Muswellbrook Waste Transfer Station

Road Safety Assessment

Prepared for Central Waste Station
April 2022

H200851 RP#13

Figure 2.5 Recommended sign and line marking measures at Thomas Mitchell Drive/Glen Munro Road intersection

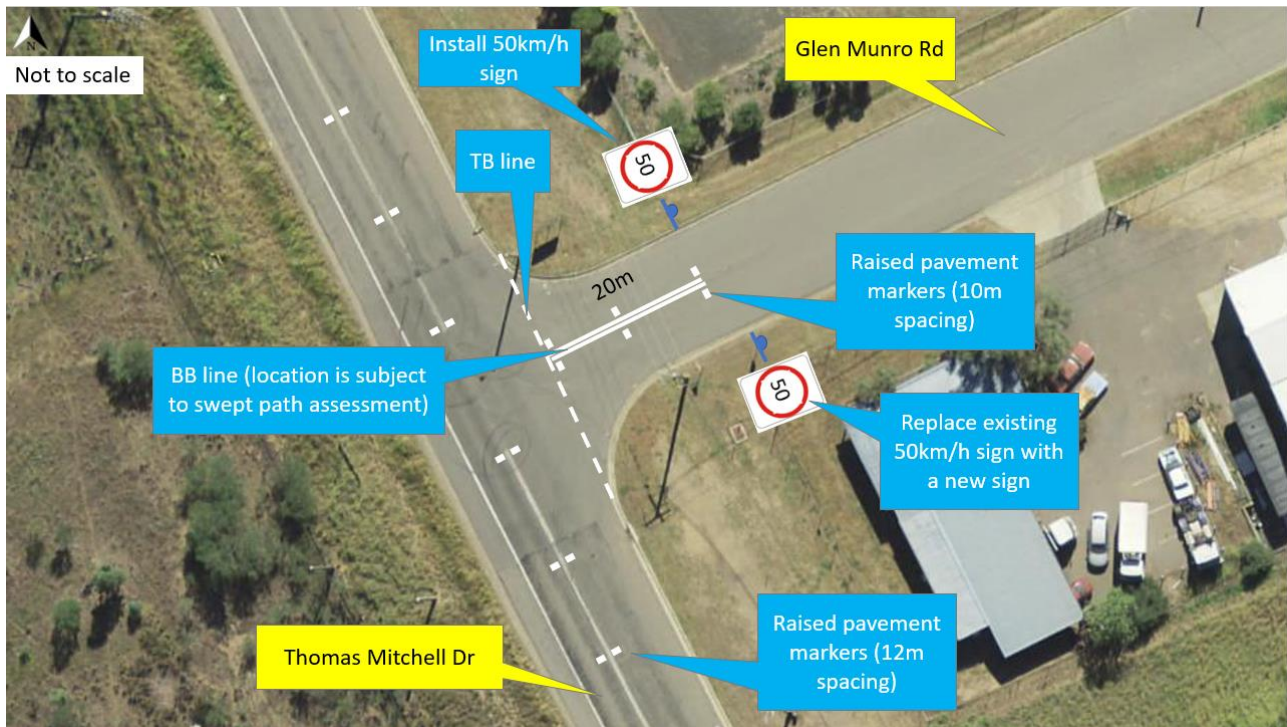
There is no existing 'give way' line marking for the traffic entering onto Thomas Mitchell Drive from Glen Munro Road. Installing 'give way' line marking at this intersection will improve safety.

Further, some motorists were observed cutting the corner while turning left or right at this intersection. Therefore, subject to swept path assessment, there is a merit of providing a BB type centre line on Glen Munro Road, which would help to prevent any illegal "corner cutting" turn movements at this intersection.

There are also no pavement reflectors on Thomas Mitchell Drive. Installing road pavement reflectors on Thomas Mitchell Drive and Glen Munro Road on each approach to the intersection will improve road safety, especially during the night time.

The full recommended signage and line marking measures for the intersection are depicted in Figure 2.5. A sign and line marking plan should be prepared by MSC for consideration by the LTC.
